Access Compliance Report Public Rights-of-Way (Curb Ramps)

Main Street: O_NEILL_DR		Cross Street: O_NEILL_DR		Location:	S
ADA ID: RPRK211102131658	Ramp Type:Type 1 - Perpendicular	Initial Pass/Fail: Fail	Overall Compliance: No	Severity Score:	30

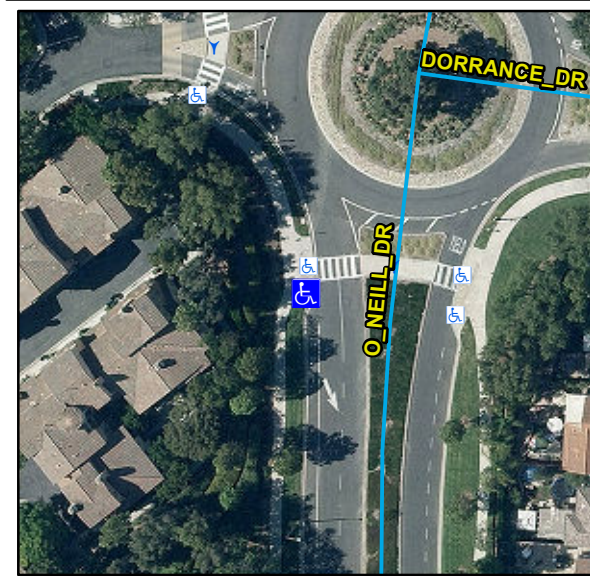
R204.3, R304.2.2, STD 1115

Remove & Replace Entire Ramp.
